Device	TC23x
Marking/Step	ES-AC, AC
Package	see Data Sheet

10210AERRA

This Errata Sheet describes the deviations from the current user documentation.

Figure 1 Message buffer transfer from Message RAM to OBF

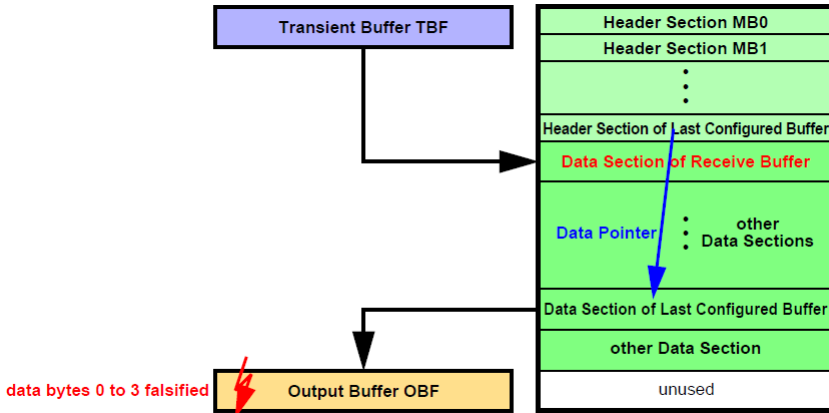
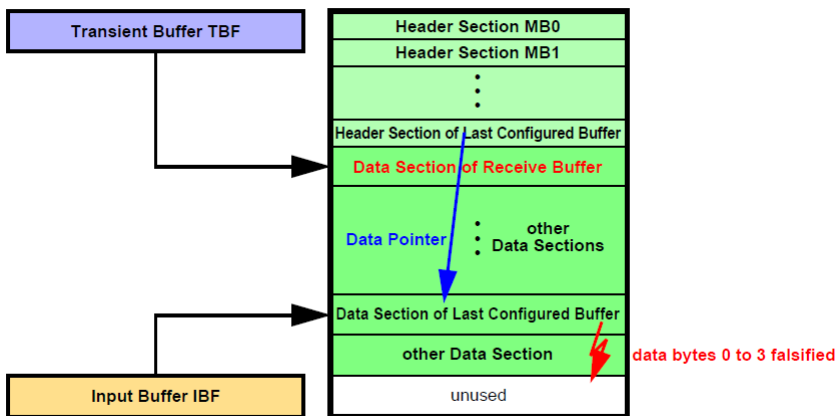
When the message buffer has its payload configured to maximum length (PLC = 127), the OBF word on address 00h (payload data bytes 0 to 3) is overwritten with unexpected data at the end of the transfer.

After the Data Section of the selected message buffer in the Message RAM has been written, one additional write access overwrites the following word in the Message RAM which might be the first word of the next Data Section.

Figure 3 Message RAM Configurations

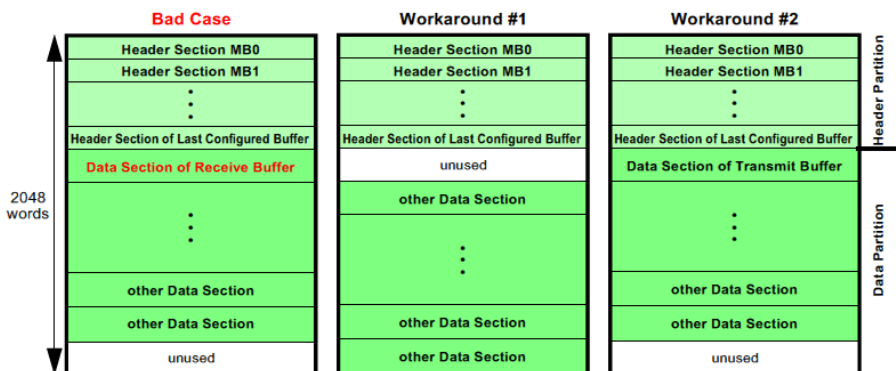
The erratum is limited to the case when (see [Figure 3](#) “Bad Case”):

- a) When a message is transferred from the Last Configured Buffer in the Message RAM to the OBF and **PLC = 127** it may happen, that at the end of the transfer the OBF word on address 00h (payload data bytes 0 to 3) is overwritten with unexpected data (see [Figure 1](#)).
- b) When a message is transferred from IBF to the Last Configured Buffer in the Message RAM, it may happen, that at the end of the transfer of the Data Section one additional write access overwrites the following word, which may be the first word of another message's Data Section in the Message RAM (see [Figure 2](#)).

2) Ensure that the Data Section directly following the Header Partition is assigned to a transmit buffer.

Figure 4 Transmitter - winning CAN FD node

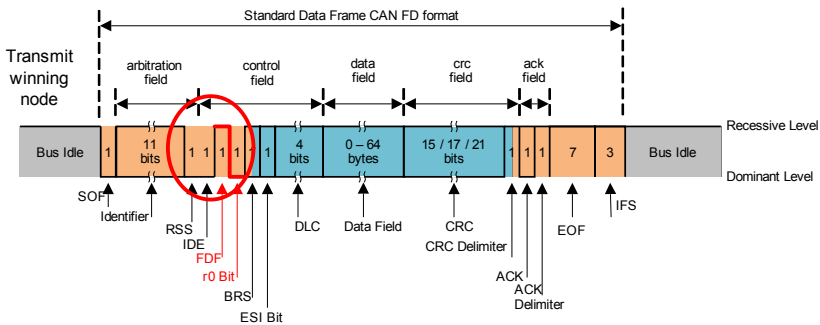
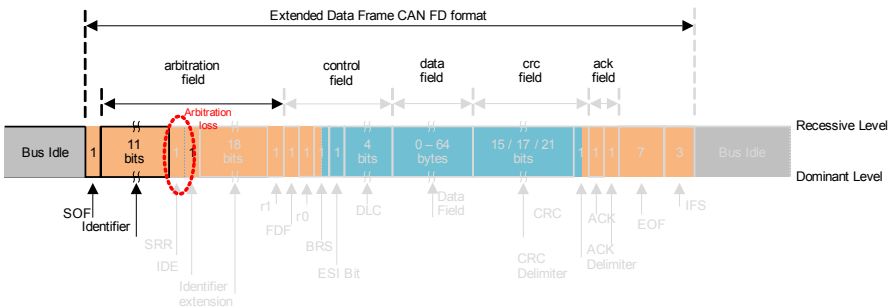
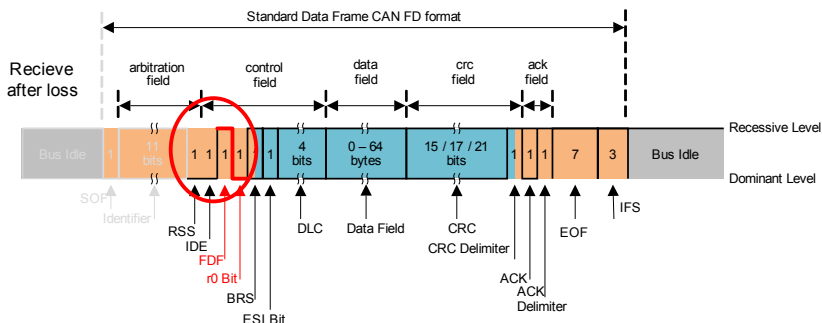
If a transmitter is losing arbitration late (e.g. in an extended frame - see [Figure 4](#) the node which wins arbitration and [Figure 5](#) the transmitting node losing arbitration), then the FDF bit to res bit is the last chance to synchronize to the

winning node (here as a receiver **Figure 6** the same node as in **Figure 5**). A timing offset will occur between the now receiving node and the actual transmitter.

The device is producing more error frames within a network than a device with a hardsync at the FDF bit.

Figure 13 Short Serial Message, Serial Data Encoding over 16 messages

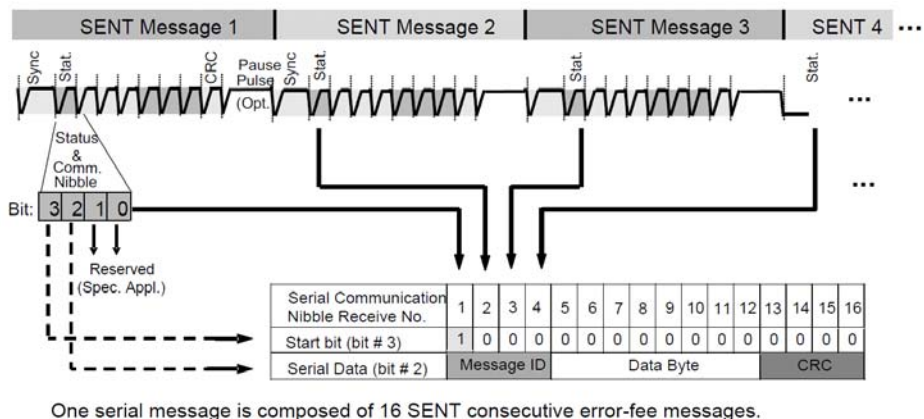
Correction

Figure 13 shows a corrected version of this figure.
